Agenda
City Council Workshop Meeting
Tuesday, January 27, 2015
City Hall Council Chamber | 505 Swift Boulevard

Proposed Amendments to the Badger Mountain South LUDR (20 minutes)

TO: PLANNING COMMISSION
FILE NO.: Z2015-100

REQUEST: TEXT AMENDMENTS TO THE LAND USE & DEVELOPMENT REGULATIONS FOR THE BADGER MOUNTAIN SOUTH MASTER PLANNED COMMUNITY.

a. **Building Height/Stories**

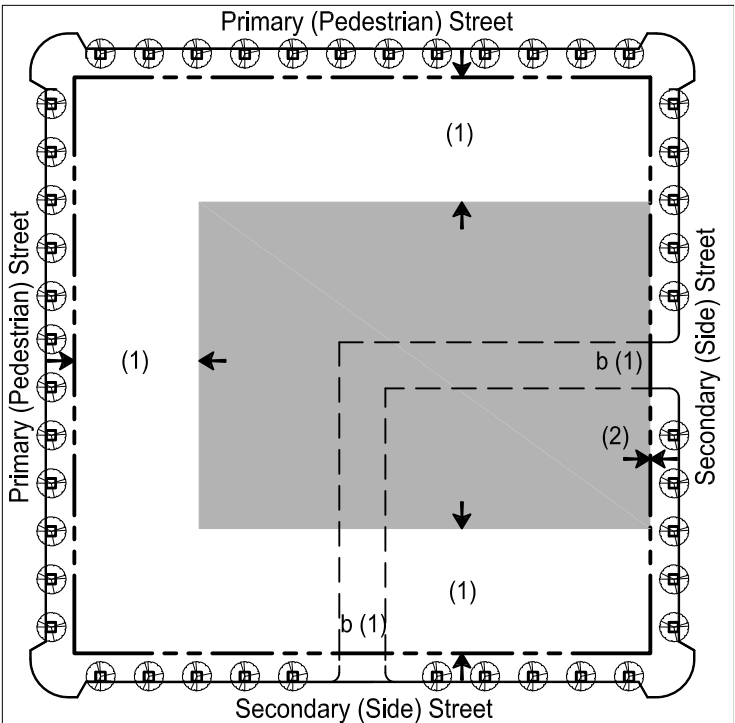
- (1) Minimum Height: ~~2 Stories~~
- (2) Maximum Height: ~~4 Stories~~
- (3) The maximum height shall be reduced to 3 Stories in the following conditions:
 - i. Buildings adjacent to outdoor Civic Spaces, such as Plazas, where solar access would be reduced.
- (4) ~~Story Height: 8 ft. minimum, 14 ft. maximum.~~
- (5) If ground floor commercial space is provided, the ground floor ceiling shall be a minimum of 12 ft. clear height, as measured from finished floor slab to underside of finished ceiling.
- (6) For flat roofs, rooftop equipment may exceed the height limit by 10 ft., provided it is located no closer than 15 ft. to edge of exterior wall, otherwise equipment shall be concealed within the attic space.
- (7) For flat roofs, a parapet is allowed to extend above the maximum height limit by 4 ft.

4. PARKING

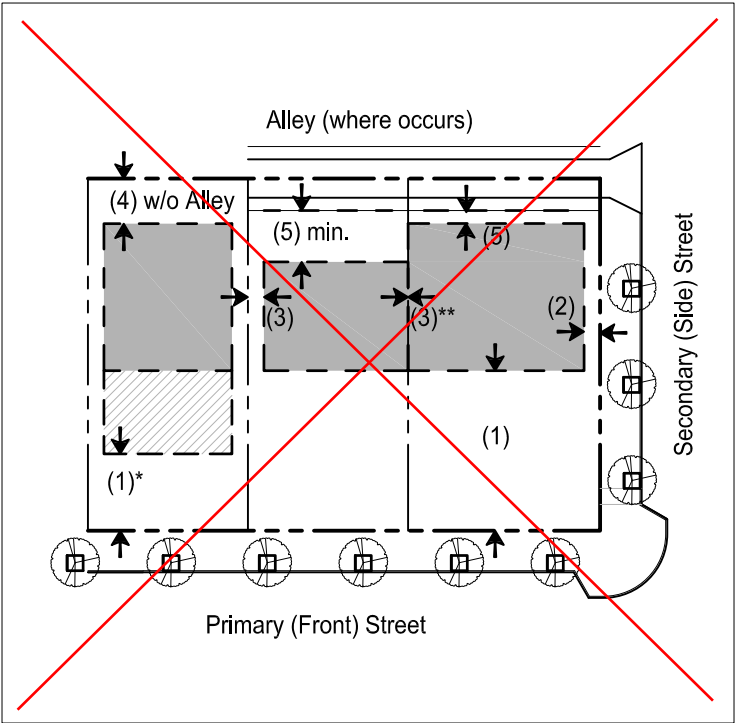
- a. **Parking Placement**
- ~~On-grade parking (enclosed or unenclosed) is allowed only in the shaded area as shown in the parking placement diagram.~~

2. BUILDING PLACEMENT

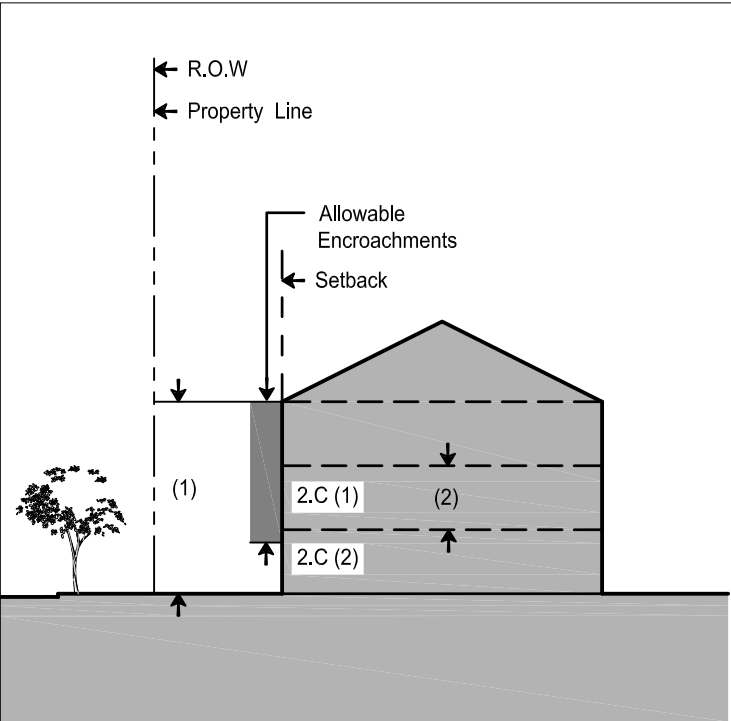
- a. Setbacks** (as measured from the property line)
- Buildings shall be placed within the shaded area as shown in the building placement diagram. ~~Parking garages shall be placed per item 4a. Parking Placement.~~ **35 ft.**

3. BUILDING PROFILE AND TYPE

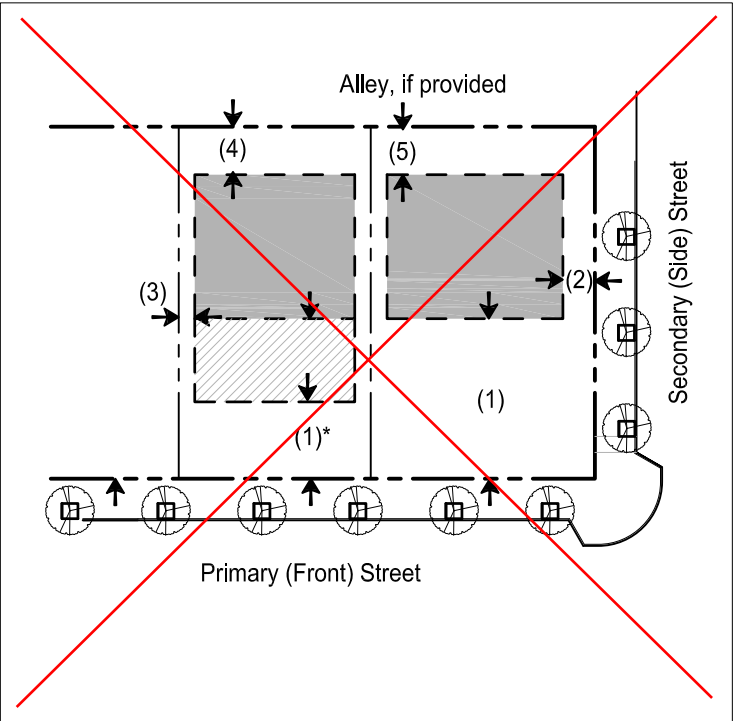
- a. Building Height/Stories**
- (1) Maximum Height: ~~3 Stories~~ **30 ft. as defined in RMC.**
 - (2) ~~Story Height: 8 ft. minimum, 12 ft. maximum.~~

2. BLOCK DIMENSIONS

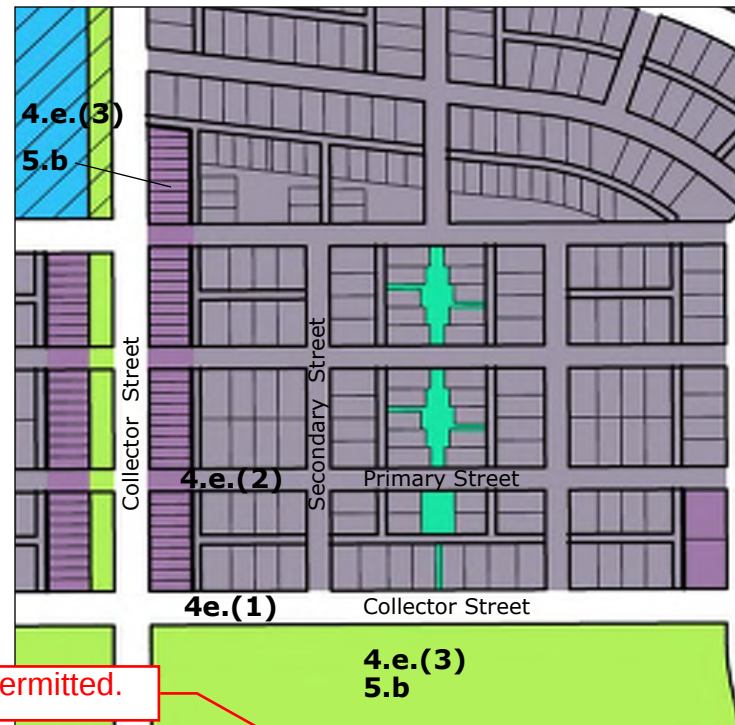
- a. Length: 1,000 650 ft., maximum *
- b. Depth: 350 ft., maximum
- c. Perimeter: 2000 ft., maximum
- d. Irregular Shaped Blocks: apply perimeter standard.
